DRAFT DECISION
Jemena Gas Networks (NSW)
Ltd
Access Arrangement

2020 to 2025

Attachment 5
Capital expenditure

November 2019

Figure 5.2 Network overheads trend

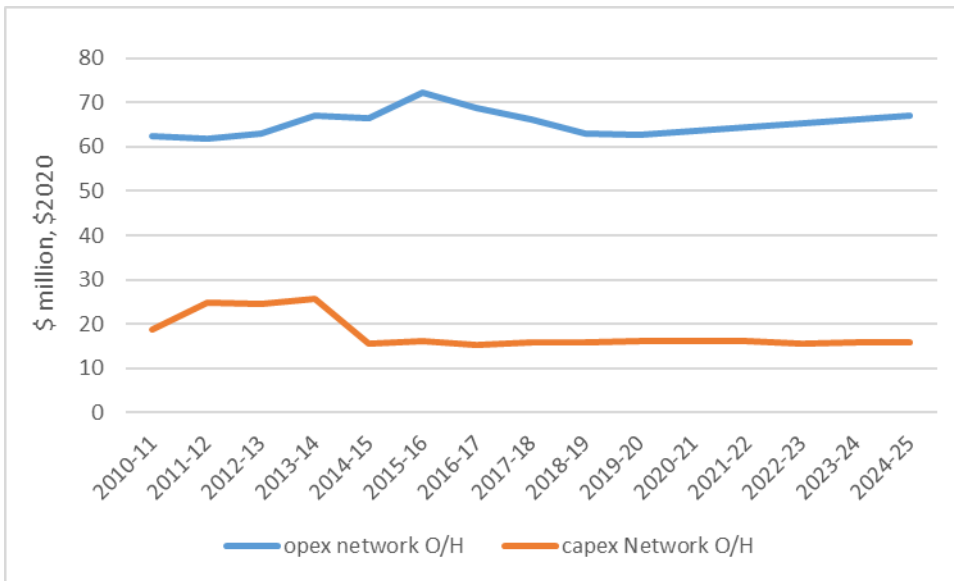
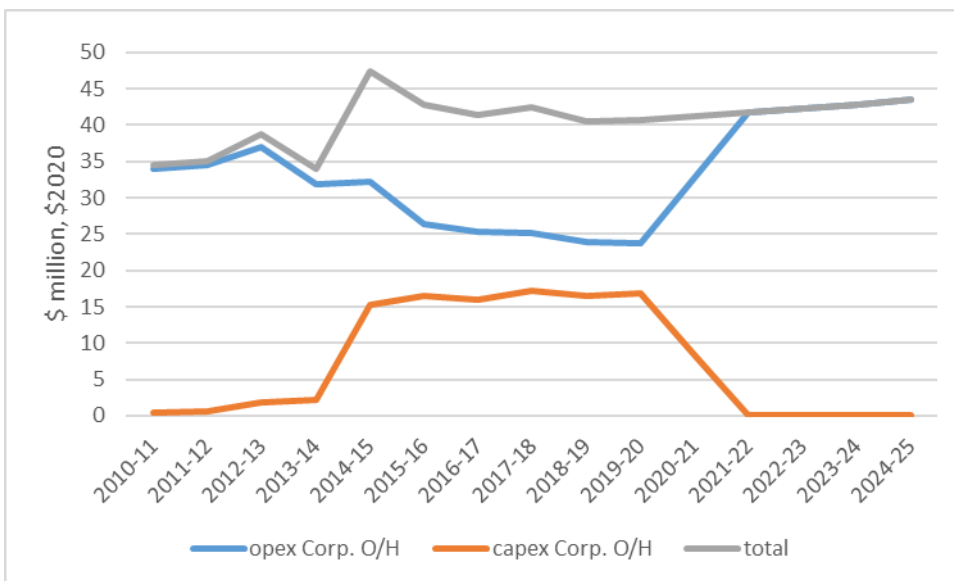
We examined JGN's RIN data for its historical overheads trend (see Figure 5.2 and Figure 5.3). The historical RIN data is considered to be a reliable source given the audit and assurance requirements.

In its response to our information request, JGN noted that the 2014–15 step changes relate to the implementation of SAP and the reclassification of IT costs from network to corporate capitalised overheads.¹⁶⁷ However, these reasons alone do not adequately address or quantify 'how' JGN overspent \$28.9 million (\$2019–20) on capitalised overheads this period against the allowance.

JGN's response to our information request does not address the reasons for the overspend of \$28.9 million (\$2019–20) on capitalised overheads this period against the allowance. Further, JGN has not provided any explanation on what this overspend was on, nor given us any comfort that no double counting has taken place.

- provide an explanation for the overspend in the corporate overheads category and the overall capitalisation overspend in the current period
- provide assurance that the movement of overheads between capex and opex does not contain any double counting of costs under the regulatory regime.
